OVERLOOK AT HOMESTEAD FILING NO. 1
 EL PASO COUNTY, COLORADO
 CONSTRUCTION DOCUMENTS
 GENERAL NOTES

PRELIMINARY
 FOR REVIEW ONLY
 NOT FOR
 CONSTRUCTION

OVERLOOK AT HOMESTEAD FILING NO. 1
 EL PASO COUNTY, COLORADO
 CONSTRUCTION DOCUMENTS
 CUT AND FILL MAP

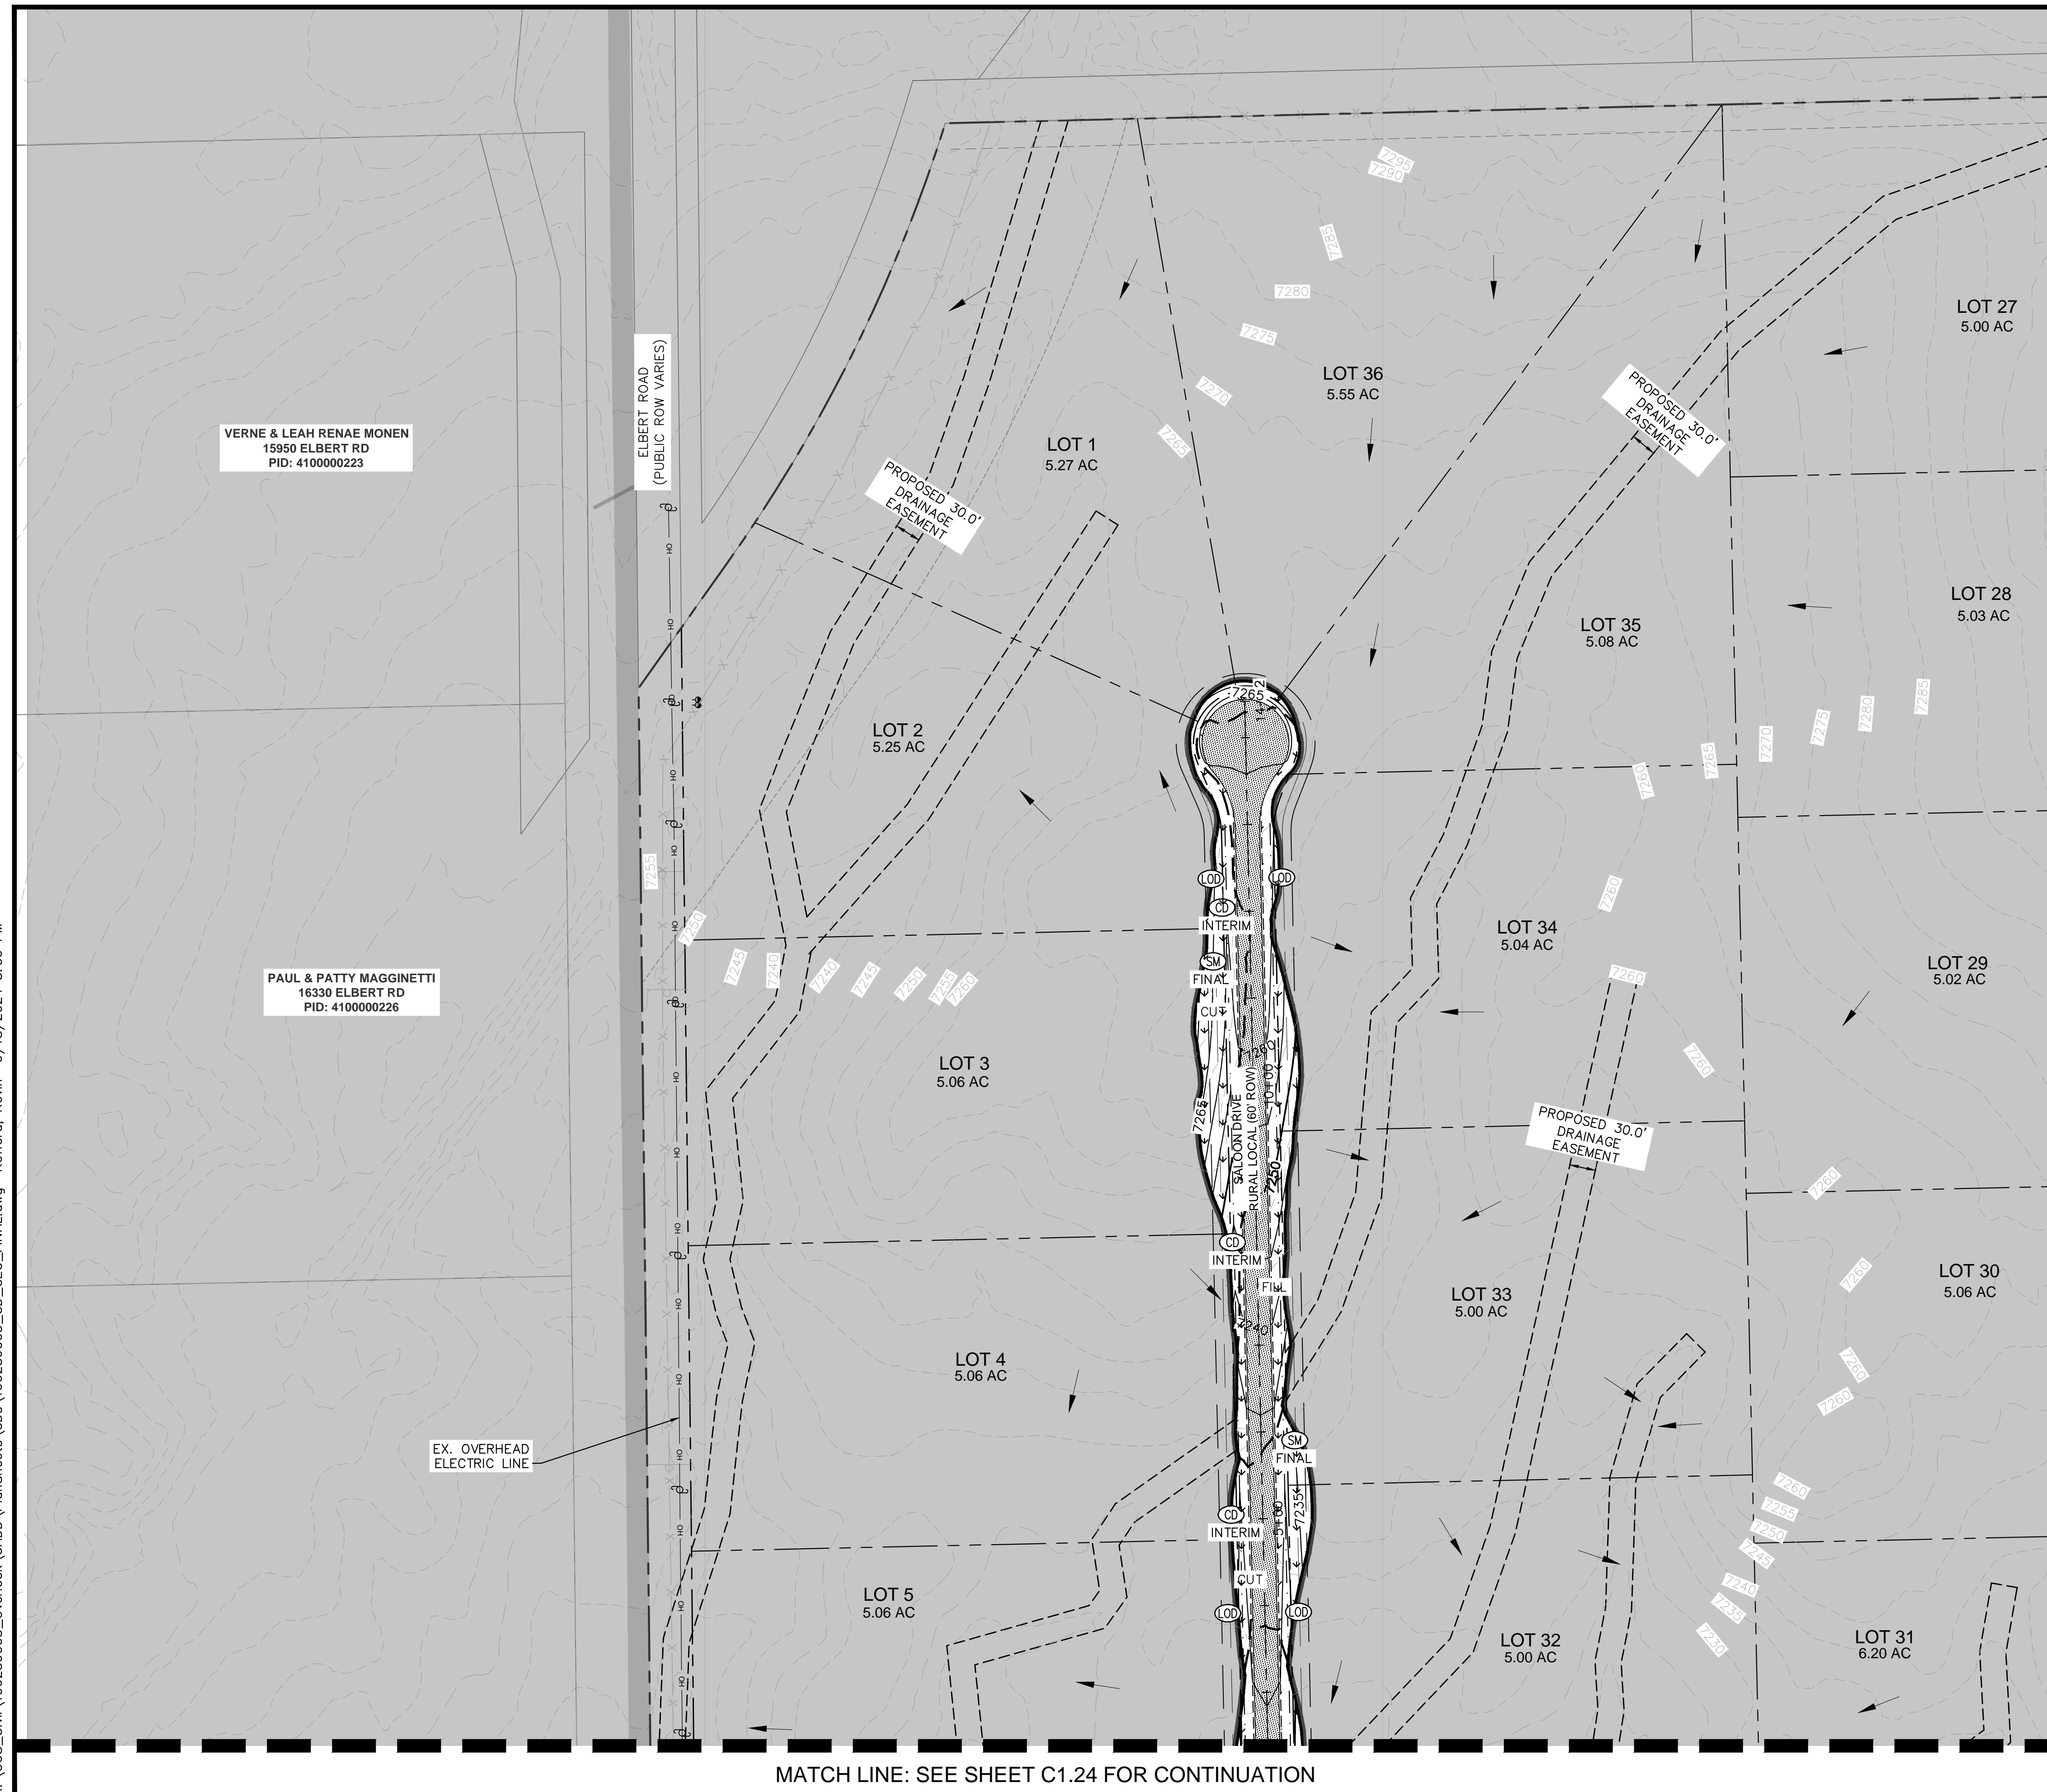
or do not submit a separate GEC plan set and include within the CD set. You may tell the planner to remove from list of items if including in the CD set.

OVERLOOK AT HOMESTEAD FILING NO. 1
 EL PASO COUNTY, COLORADO
 CONSTRUCTION DOCUMENTS
 POND A2 OVERVIEW

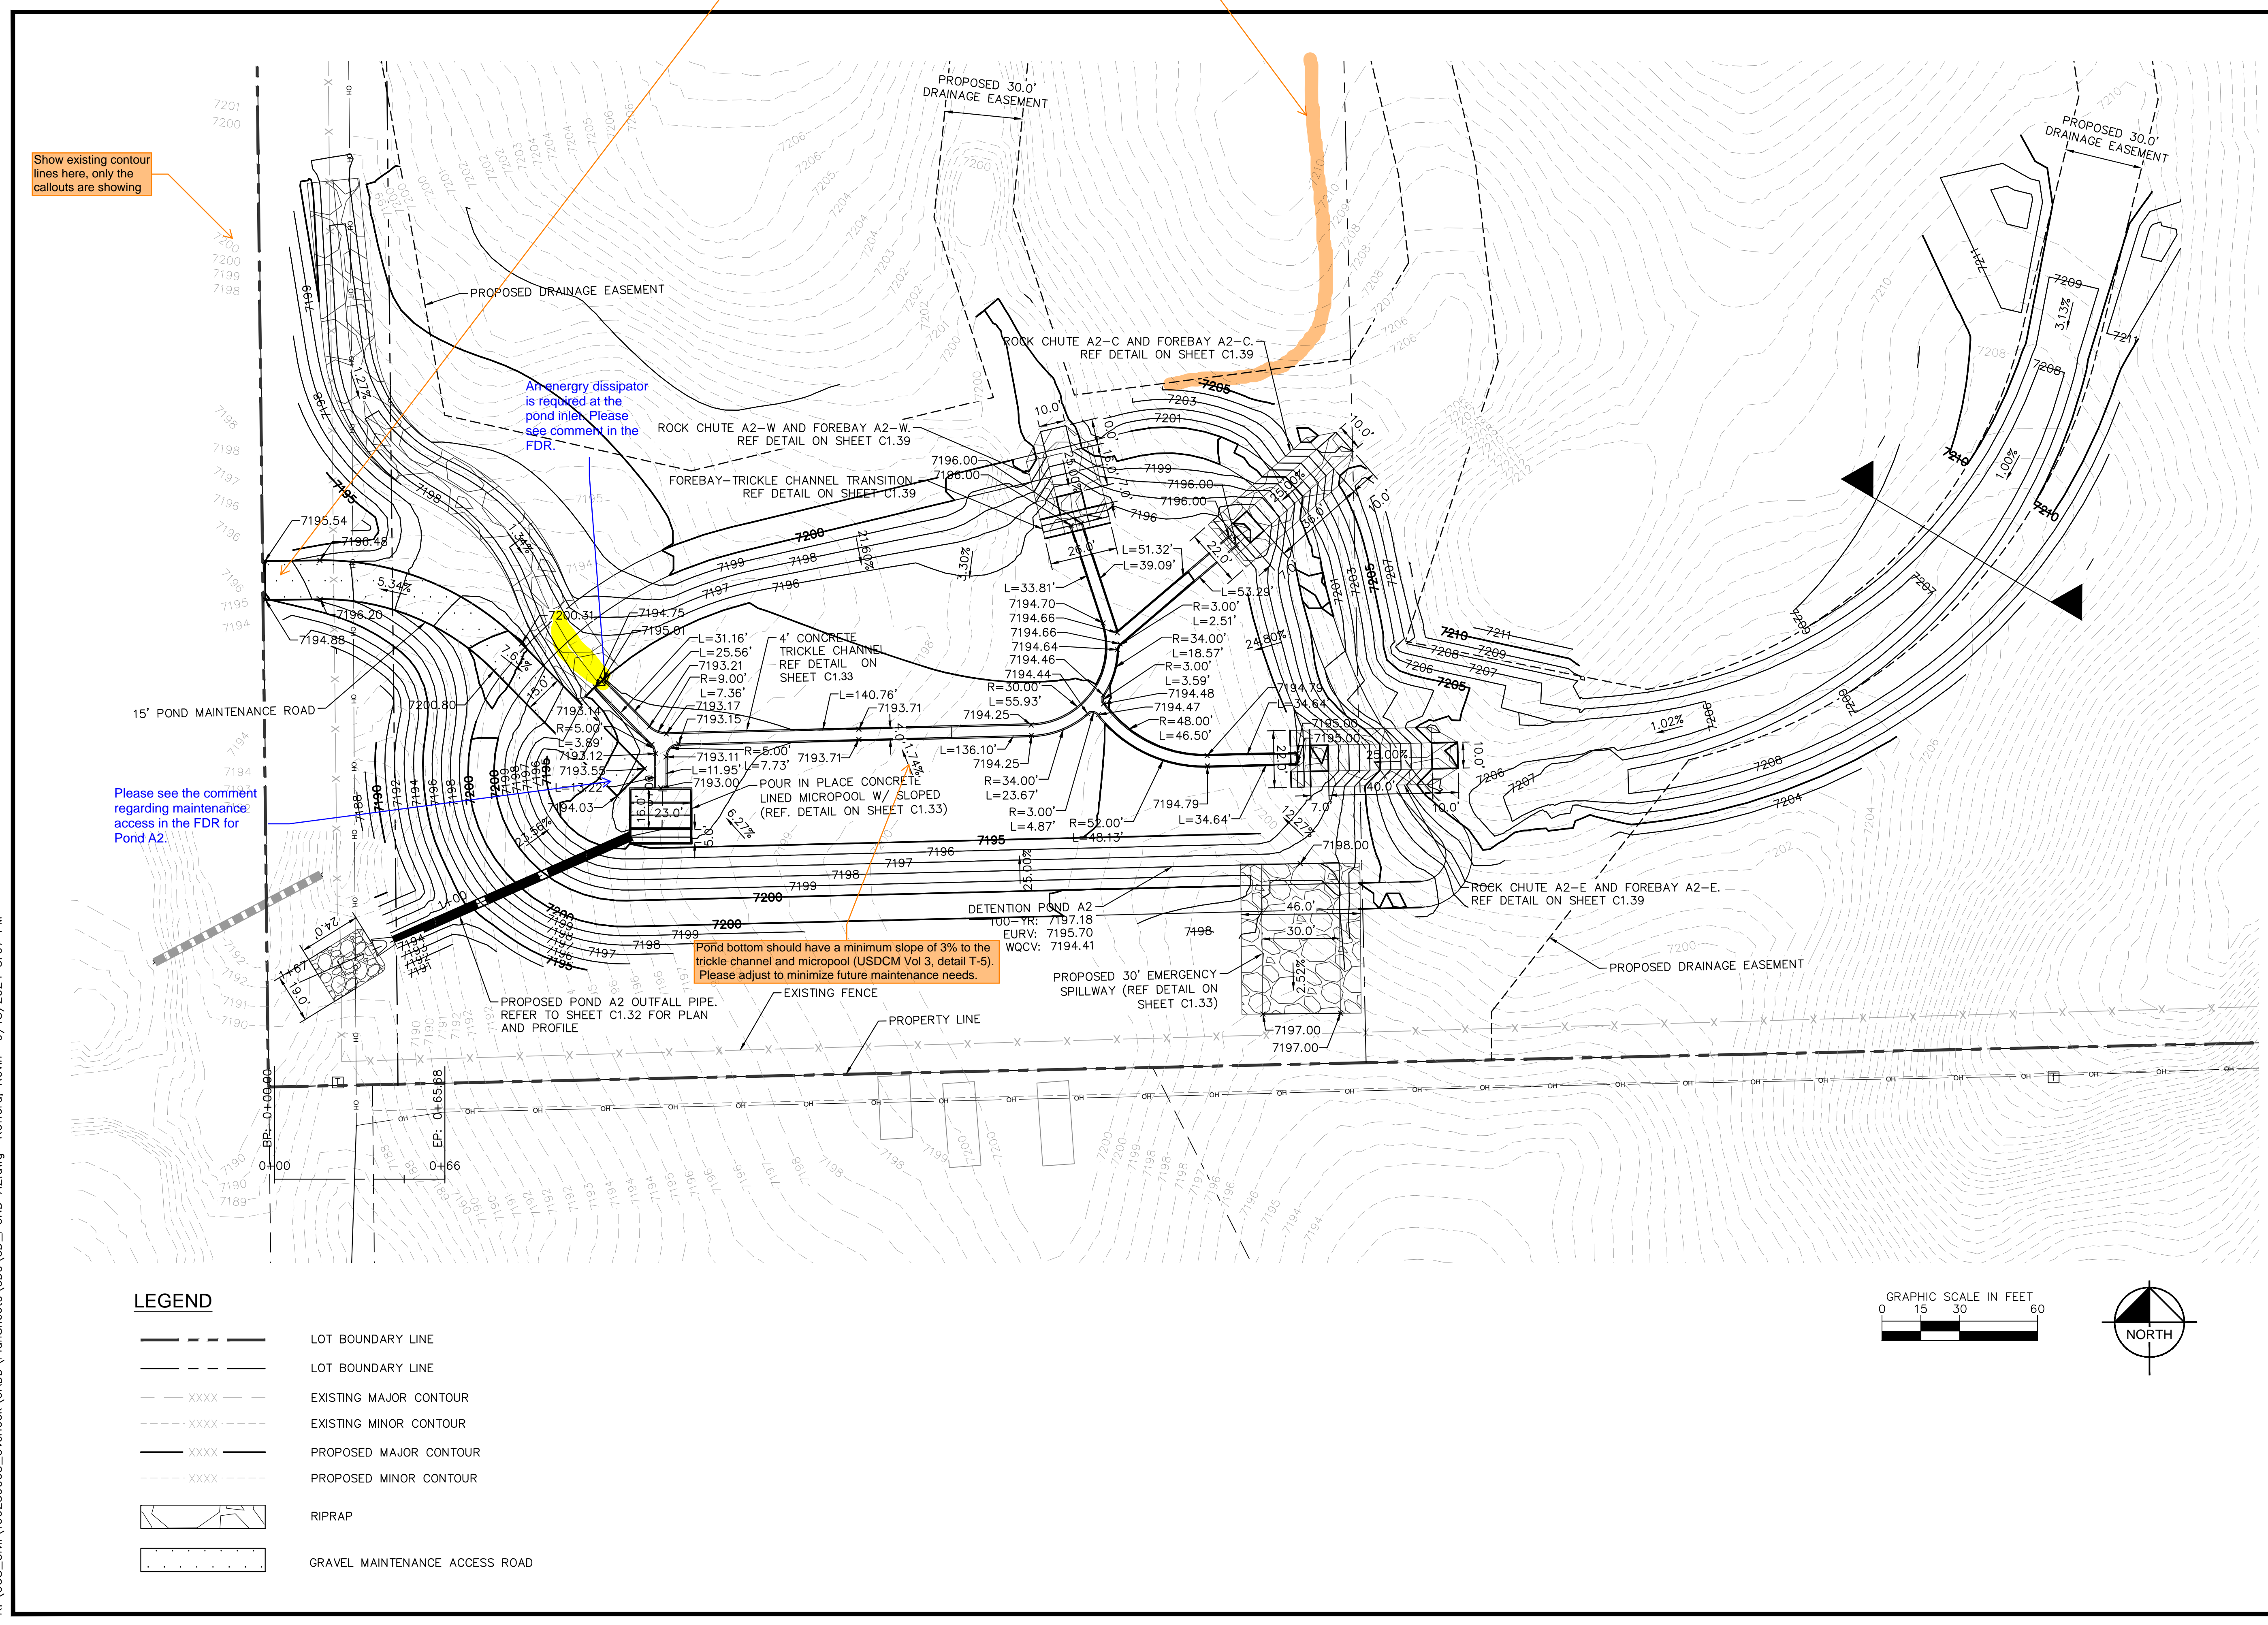
Show existing contour lines here, only the callouts are showing

An energy dissipator is required at the pond inlet. Please see comment in the FDR.

Please see the comment regarding maintenance access in the FDR for Pond A2.

Pond bottom should have a minimum slope of 3% to the trickle channel and micropool (USDCM Vol 3, detail T-5). Please adjust to minimize future maintenance needs.

10 SECTION CREST WALL DETAIL
1" = 2"

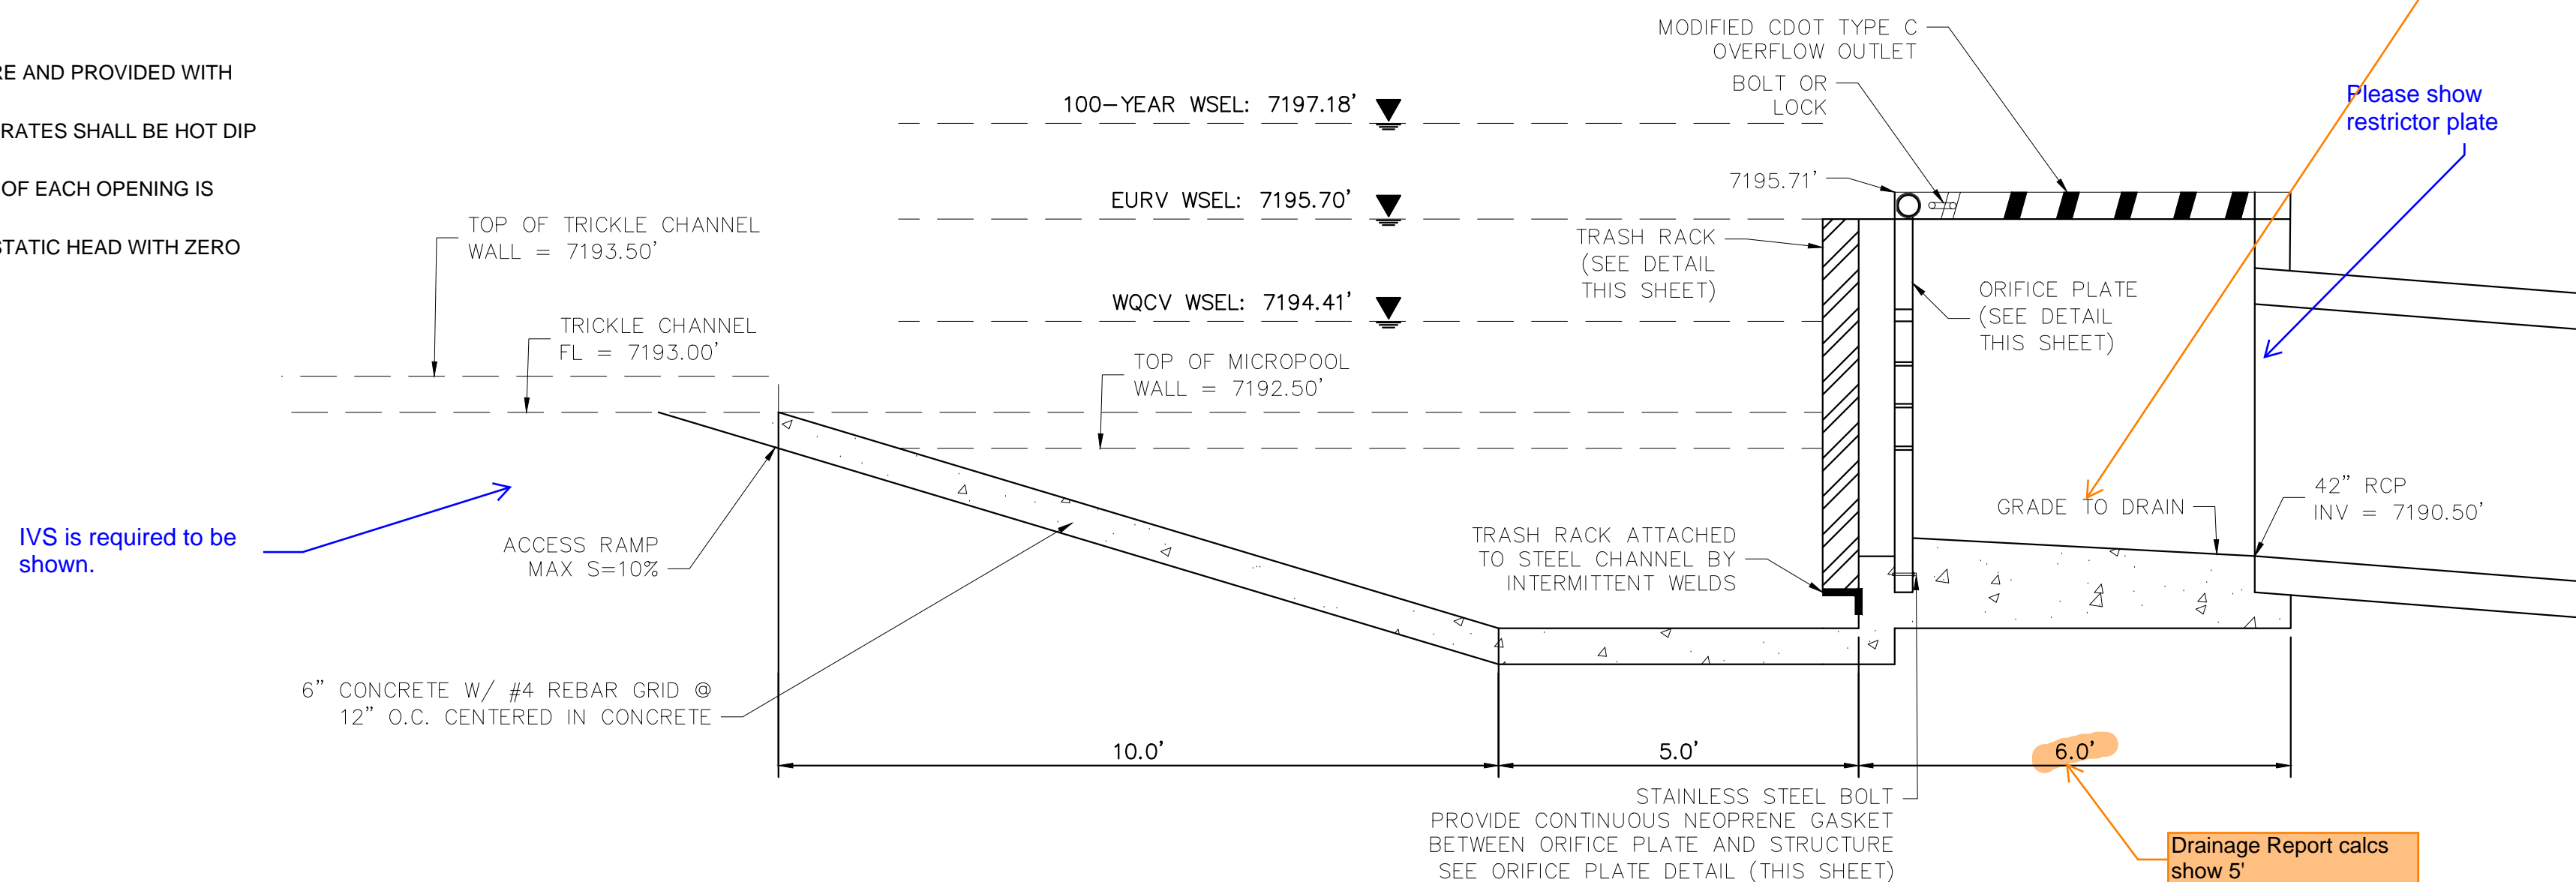
Per USDCM T-12, the outlet structure bottom should have a shaped invert of 2.5% minimum slope (if the invert of the outlet pipe is at the bottom of the outlet structure). And show line for top of micropool walls. A safety rail should be included for vertical drops of 3 feet or more.
